Wisconsin Department of Transportation

Proposal #14: 1130-64-71, WISC 2025135
Appleton – De Pere
I-41 Mainline, STH 96 – RR Bridge
IH 041
Outagamie County

Letting of December 10, 2024

This is Addendum No. 03, which provides for the following:

Addendum No. 03
ID 1130-64-71/72/87
Revised Sheet 51
December 5, 2024

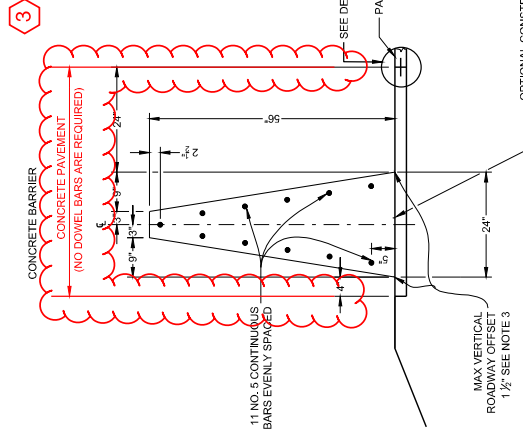
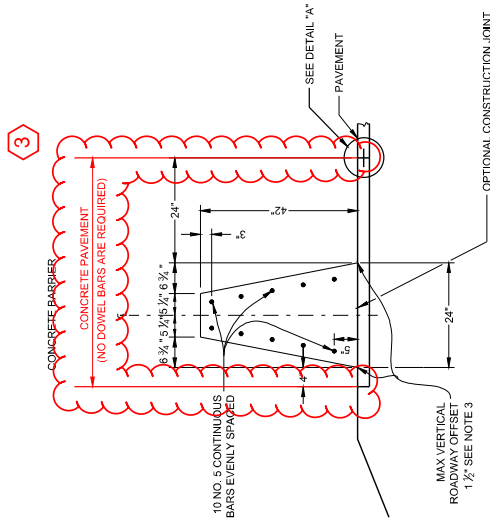
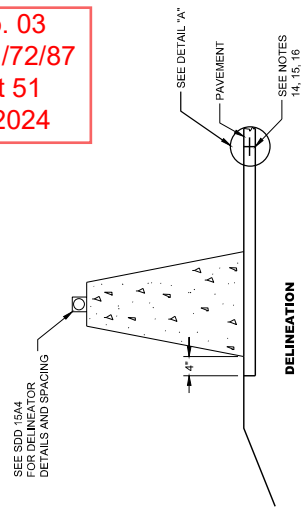
Revised Plan Sheets	
Plan Sheet	Plan Sheet Title (brief description of changes to sheet)
36	Typical Finished Sections: Updated location of concrete barrier.
51	Construction Details: Added note indicating dowel bars not required beneath concrete barrier.
67	Construction Details: Updated dimensions.
75	Construction Detail-Ground Improvement Detail: Added note identifying cutoff elevation.
76	Construction Details-Rigid Inclusion Cap Details: Removed note making reinforcement incidental to cap
92	Construction Detail-Drainage: Removed note for monolithic shimming.
97	Construction Detail-Drainage: Added detail and notes for monolithic shimming.
100-101	Construction Details-Drainage: Updated heading of table.
145-146	Removal Plan-Stage 2-Mainline: Updated location of fence removal.
191	Plan Details-IH 41 Mainline: Updated location of Concrete Barrier Type S56A.
257-258	Plan Details-Lynndale Drive: Updated location of barrier wall and added a concrete barrier transition.

Addendum No. 03
ID 1130-64-71/72
Revised Sheet 92
December 5, 2024

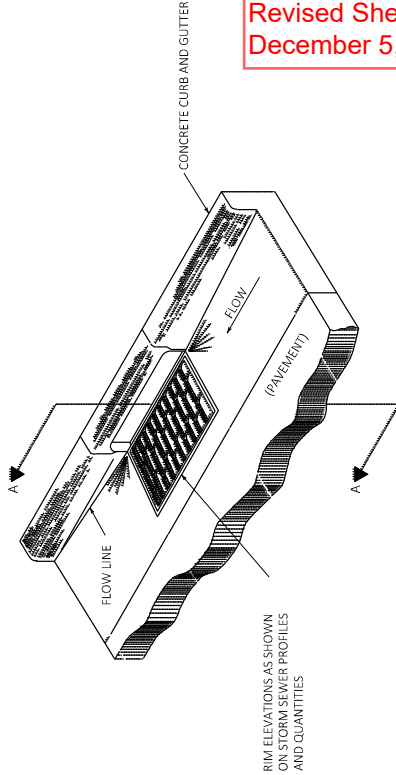
Deleted Plan Sheets	
Plan Sheet	Plan Sheet Title (brief description of why sheet was deleted)
93	Construction Details-Drainage: The monolithic shimming detail was added to the Double Grate Inlet Section (p. 97 of plan) in this addendum. Additionally, concrete shimming is only required at VV-B Inlet Covers on IH 41.

(1) PROVIDE MONOLITHIC CONCRETE SHIMMING FOR FINAL ADJUSTMENT OF DRAINAGE STRUCTURES LOCATED WITHIN THE ROADWAY CONCRETE PAVEMENT AND CONCRETE BARRIERS.

Addendum No. 03
ID 1130-64-71
Added Sheet 808A
December 5, 2024

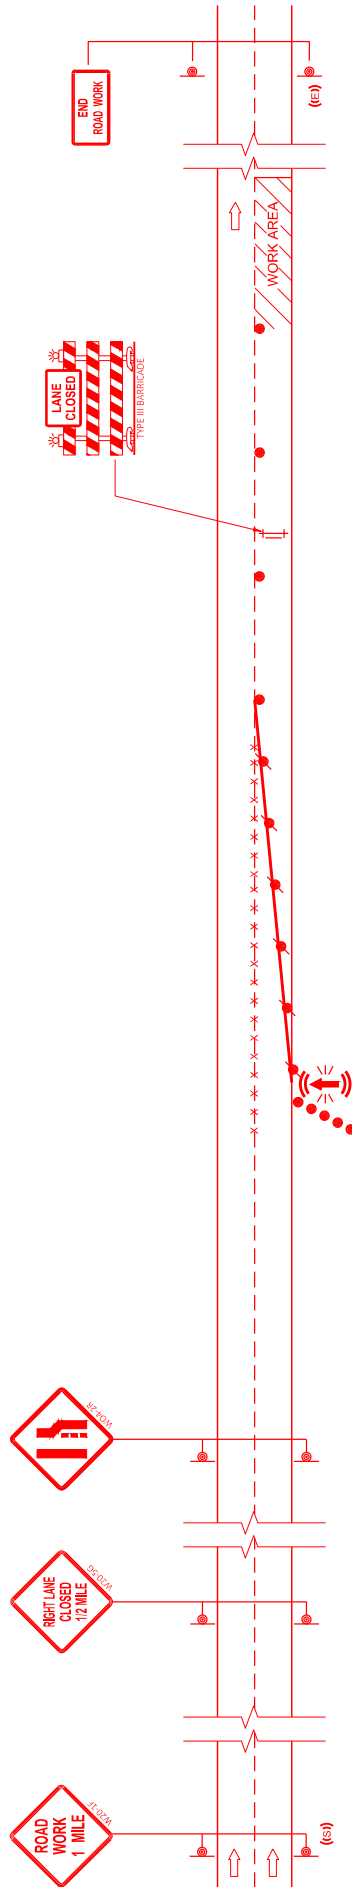
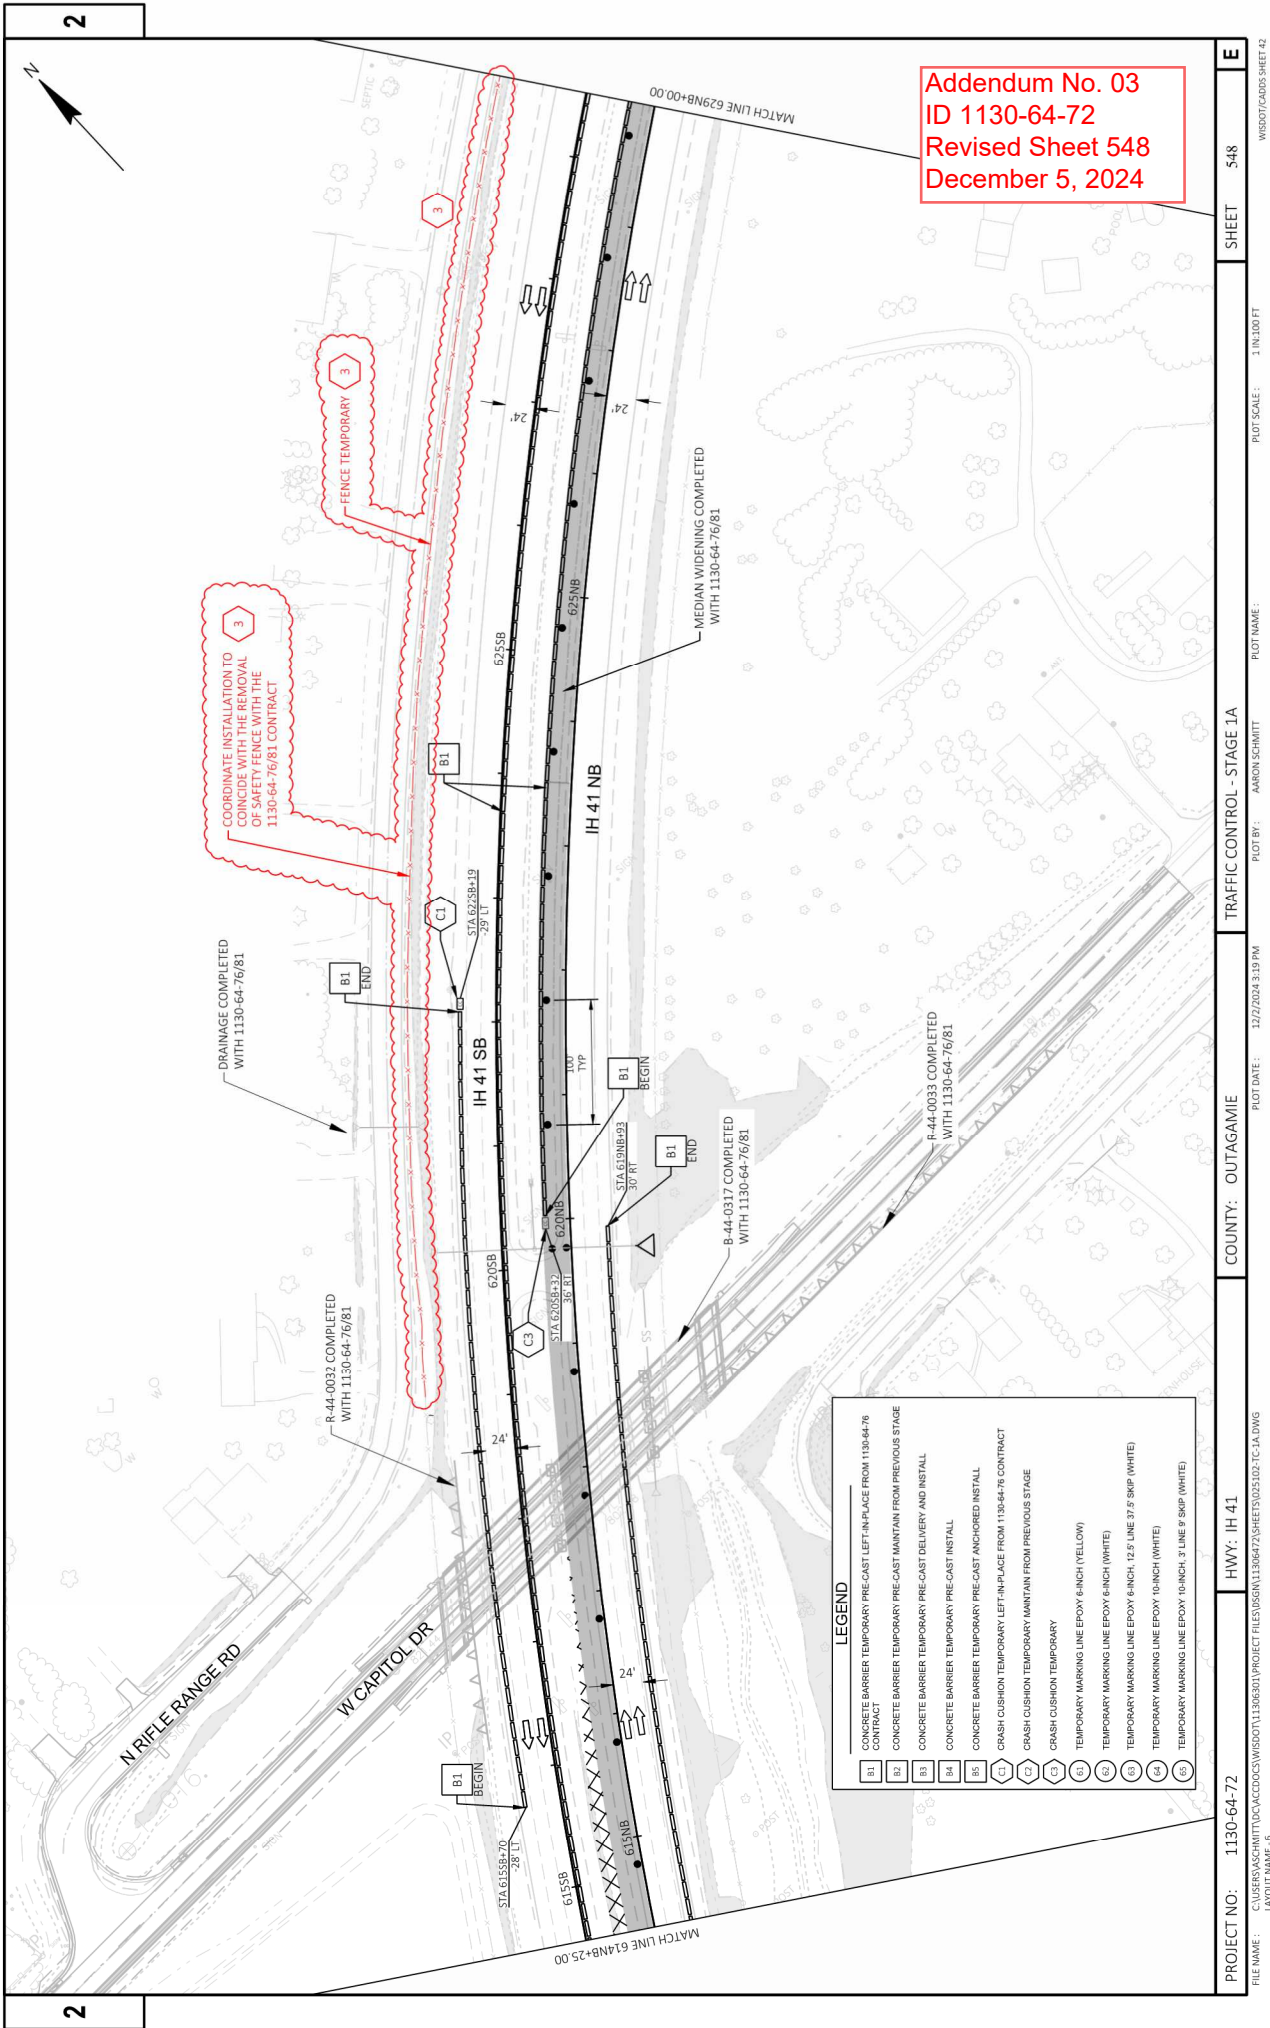
Added Plan Sheets	
Plan Sheet	Plan Sheet Title (brief description of why sheet was added)
538A	Traffic Control Details: Added detail for using work zone location markers during lane closures.
808A	Miscellaneous Quantities: Added table for connected work zone devices
901A	Miscellaneous Quantities: Added table for connected work zone devices
1057A	Standard Detail Drawing: Added SDD 8D14, Slotted Vane Drain
1649A-B	Earthwork Data: Added end area for Lynndale Drive (CTH A).

THIS CONSTRUCTION DETAIL SUPPLEMENTS STANDARD DETAIL DRAWINGS FOR LANE CLOSURES WITH WORK ZONE LOCATION MARKERS AS SHOWN IN THIS DETAIL.
